April 30, 1993
LD-93-072

SUBJECT: SYSTEM 80+ Supplemental Information

SYSTEM 80+™

SUPPORTIVE INFORMATION FOR NUCLEAR ISLAND (NI) STRUCTURES
(2.1.1)

FIGURE 3.8-5
SH. 1 OF 12

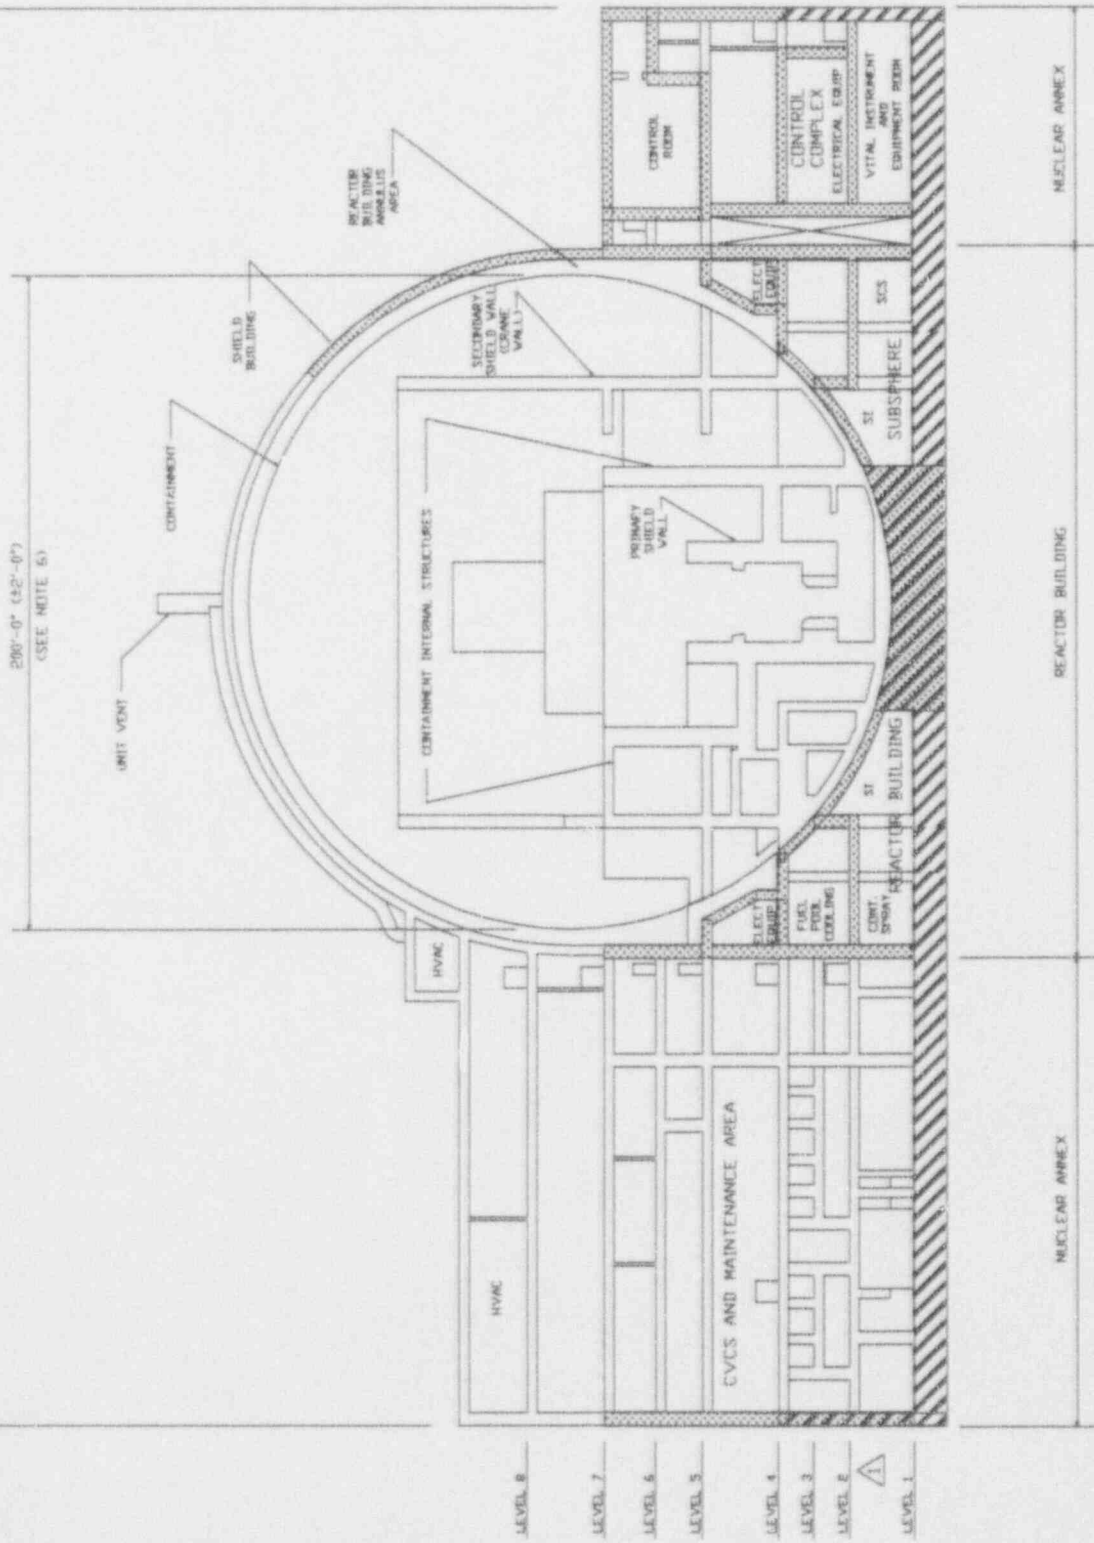
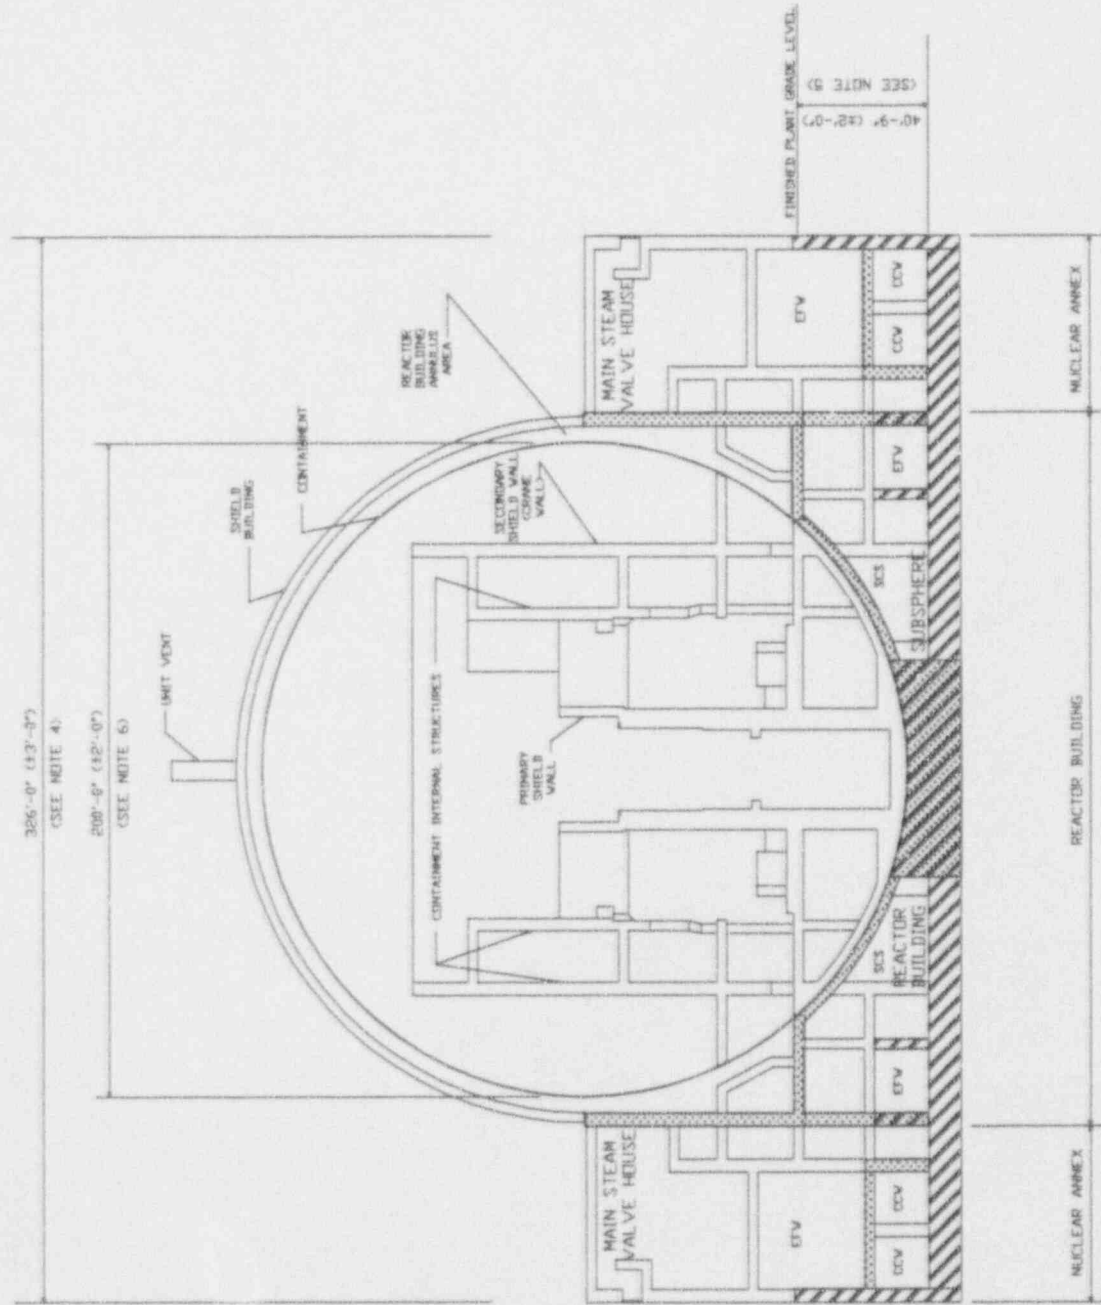
The ~~best~~ ^{arrangement} configuration of the Nuclear Island structures, which includes containment and defines critical dimensions, flood barriers, and fire barriers, is shown on Figure 3.8-5, Shs. 1-12.

The ~~arrangement~~ ^{arrangement} of the Nuclear Island Structures, which includes the internal structure and defines critical dimensions, fluid barriers, and fire barriers, is shown on Figure 3.8-5, Shs. 1-12.

The ~~basic configuration~~^{arrangement} of the Nuclear Island Structures, which includes the reactor building and defines critical dimensions, flood barriers, and fire barriers, is shown on Figure 3.8-5, Shs. 1-12.

The ~~basic configuration~~ ^{average} of the Nuclear Island structures, which includes the nuclear system annex and defines critical dimensions, flood barriers, and fire barriers, is shown on Figure 3.8-5, Sht-12.

FIGURE 3.8-5
SH. 3 OF 12

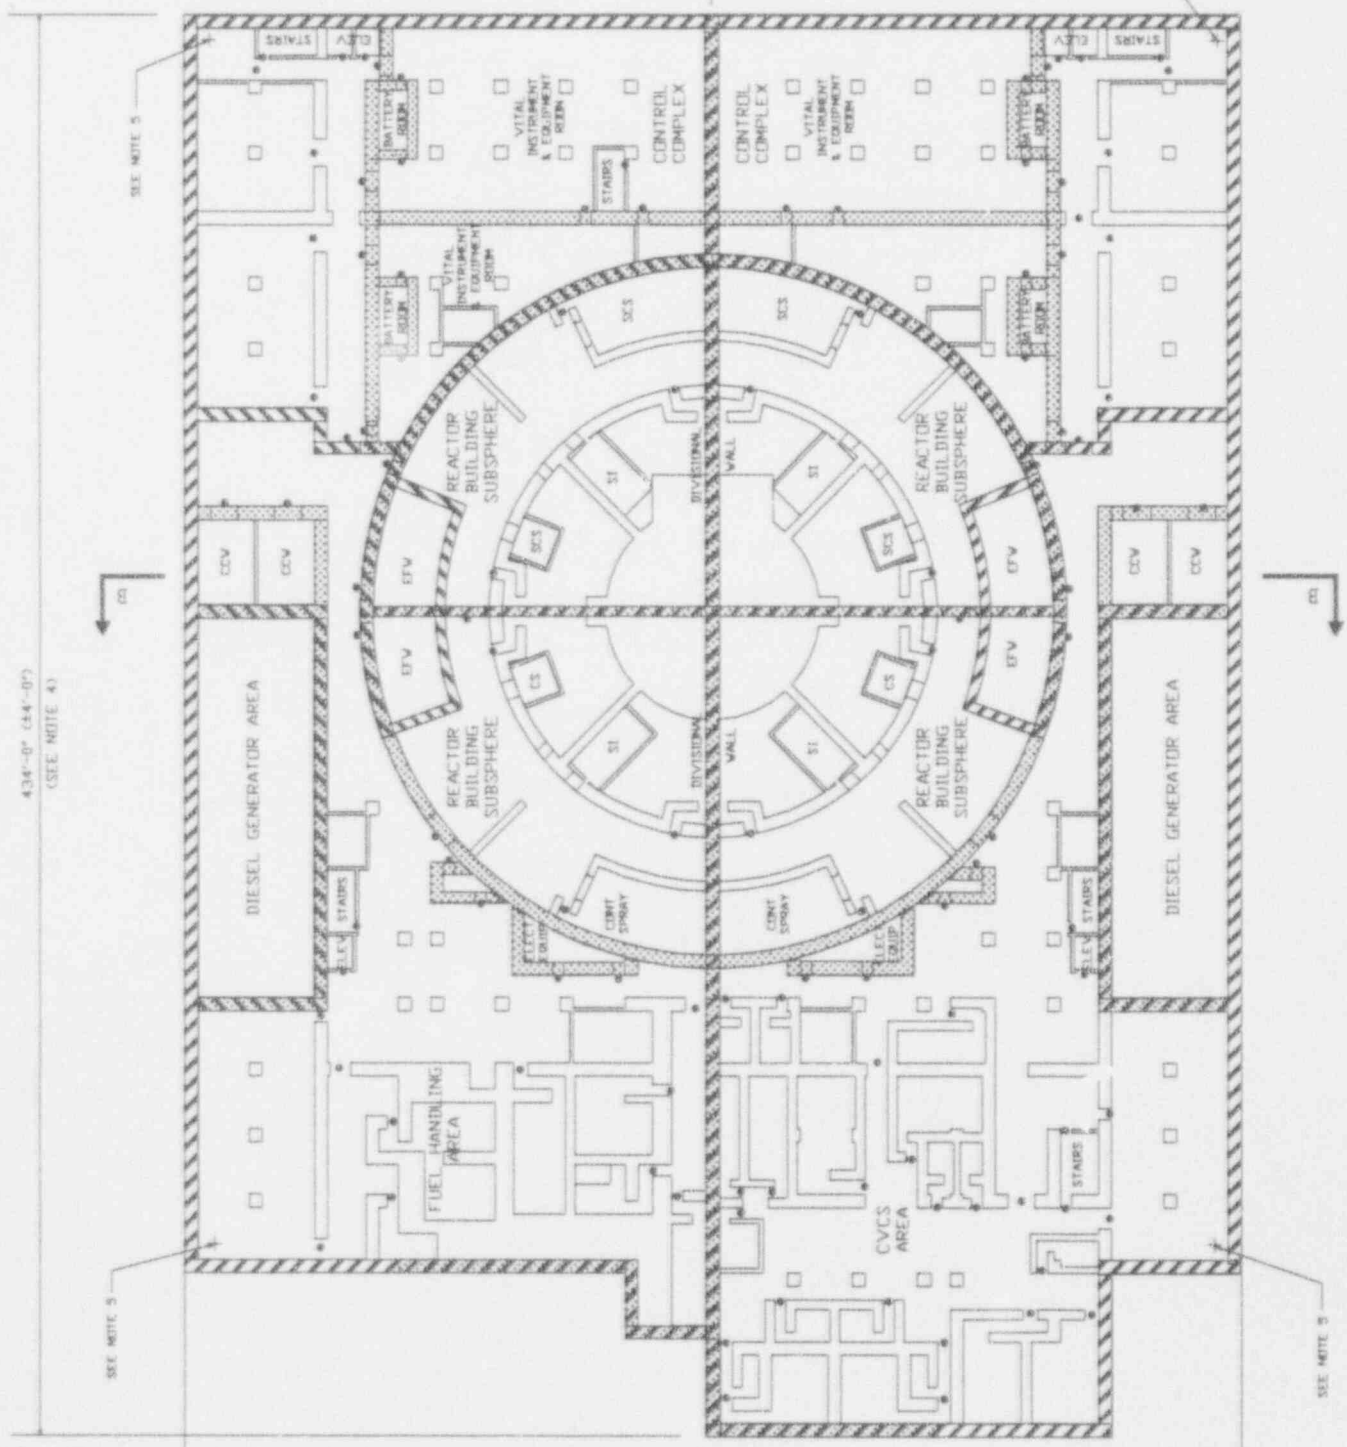
5. THIS DIMENSION IS THE DIFFERENCE BETWEEN THE PLANT GRADE ELEVATION AND THE TOP ELEVATION OF THE LEVEL 1 REINFORCED CONCRETE FLOOR AT THE LOCATIONS INDICATED ON FIGURE 3.8-5, SH. 3. THE PLANT GRADE ELEVATION IS DETERMINED AT THE EXTERIOR CORNER OF THE REINFORCED CONCRETE WALL ADJACENT TO THE LOCATIONS INDICATED ON FIGURE 3.8-5, SH. 3.

FIGURE 3.8-5
SH. 11 OF 12

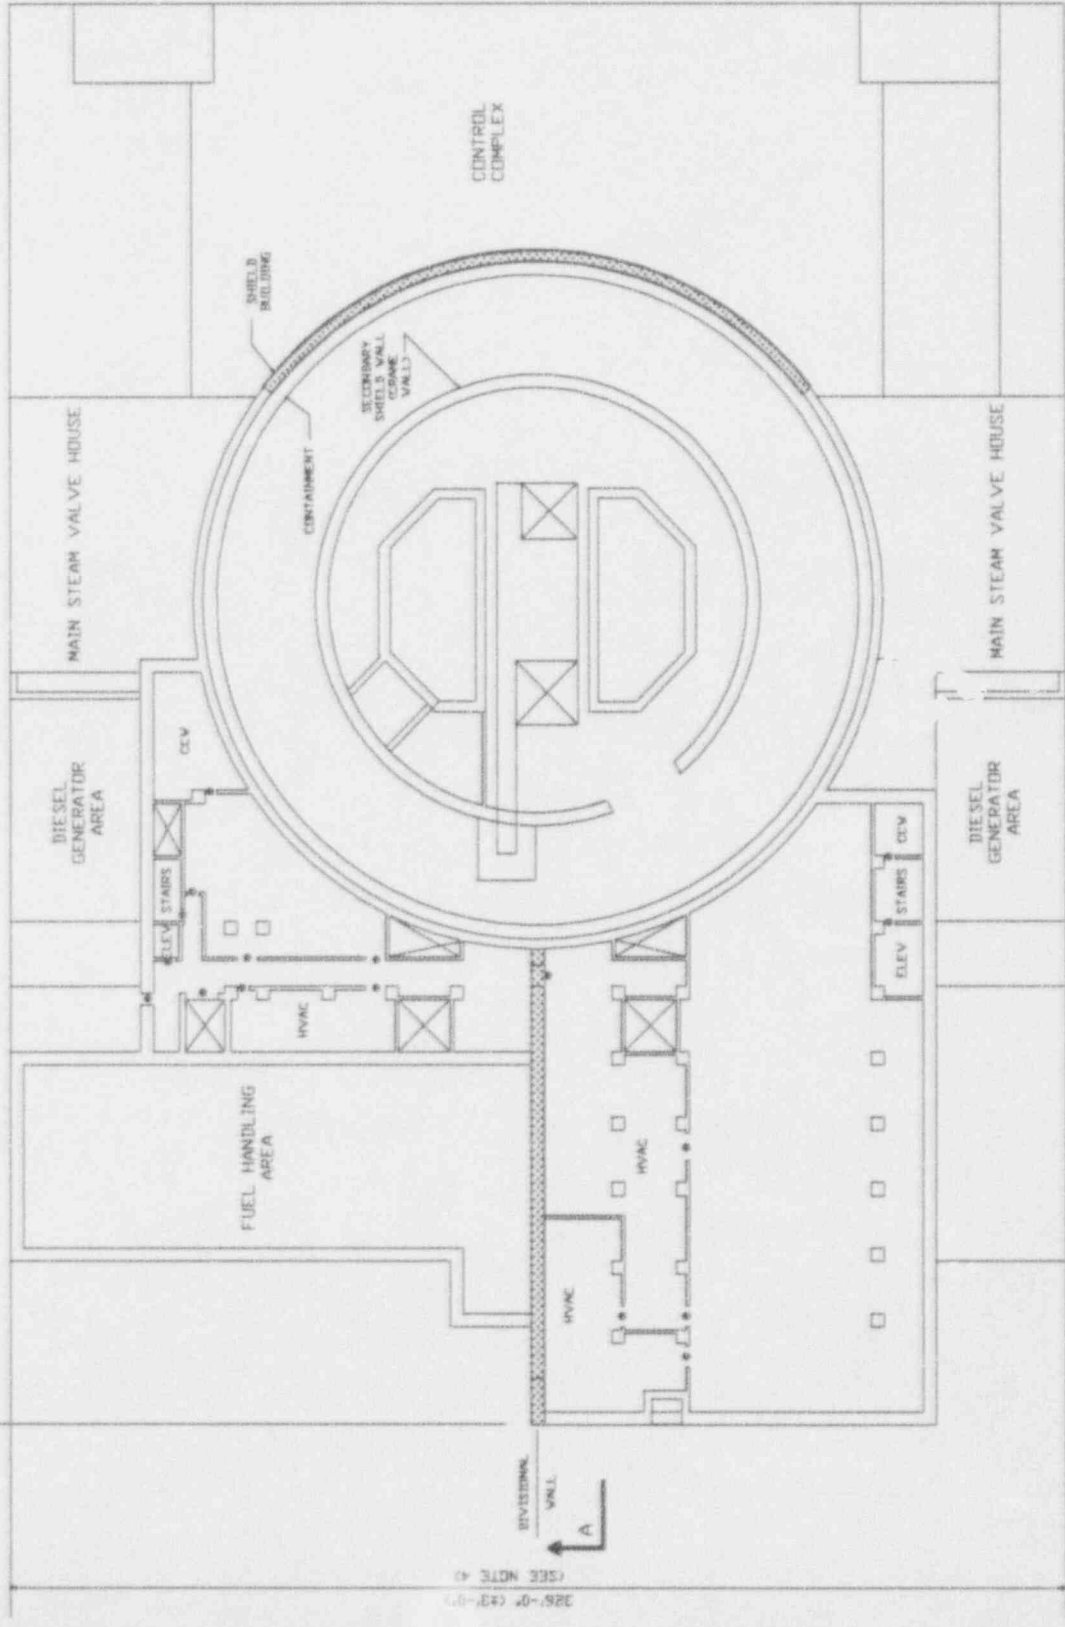
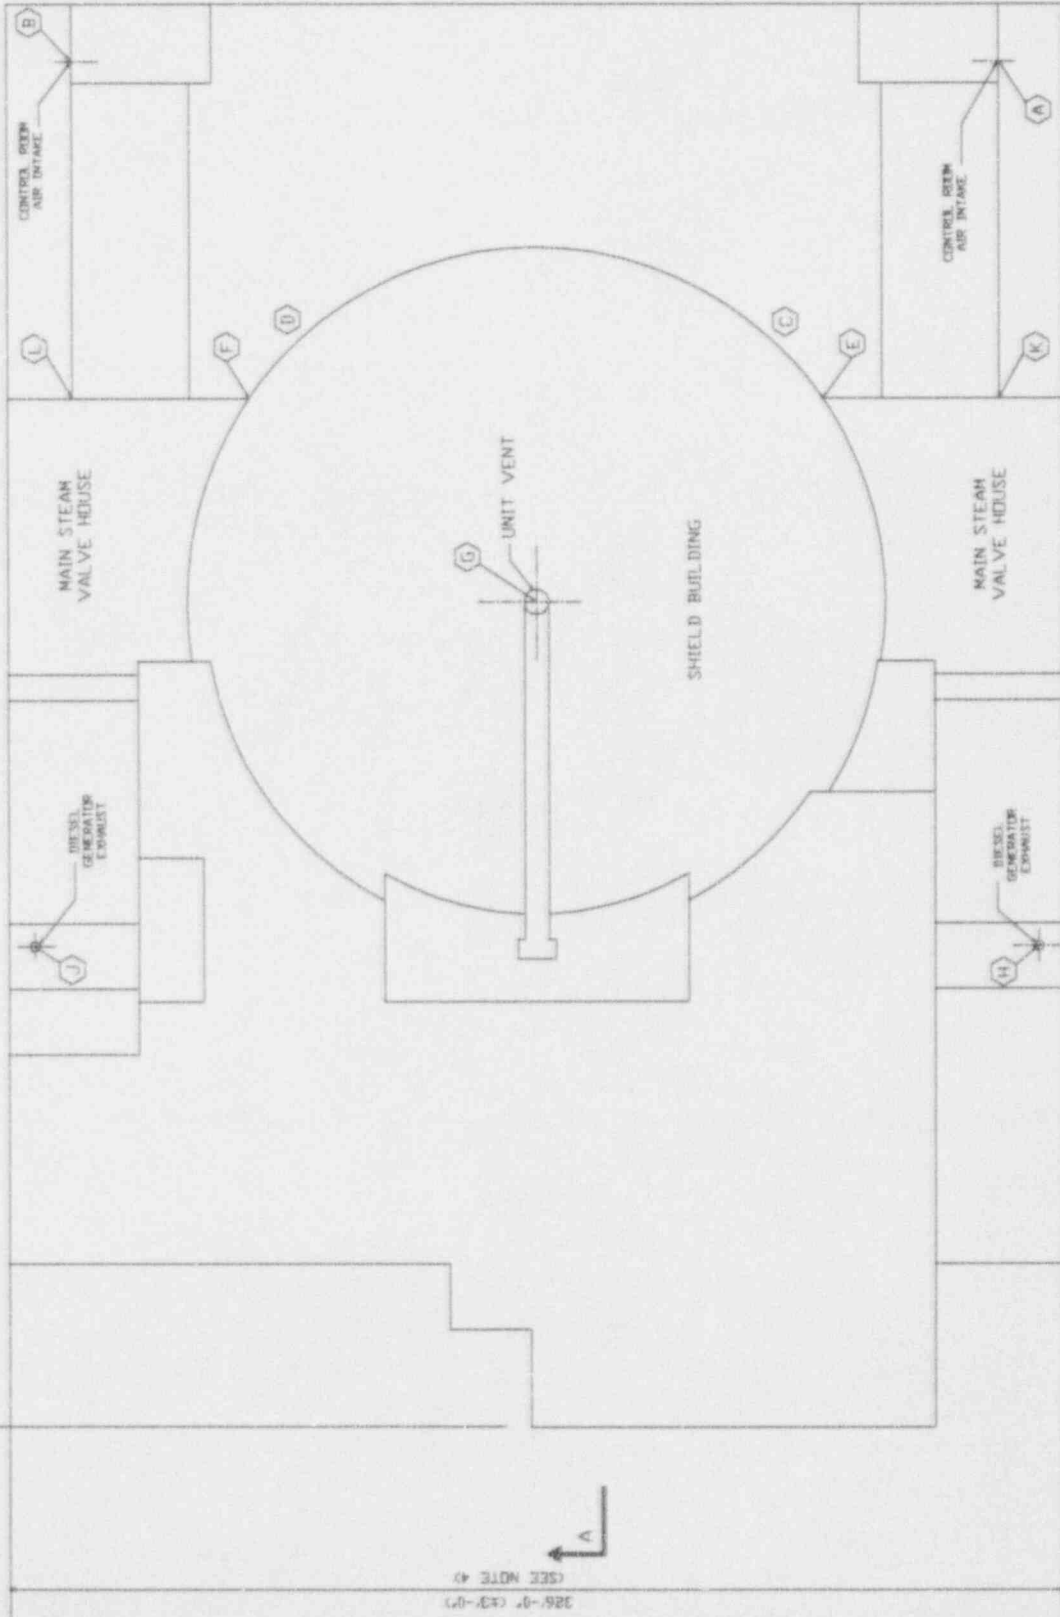
The minimum distance between the Control Room Air Intakes and ~~postulated~~ ^{postulated} plant release points is specified on Figure 3.8-5.
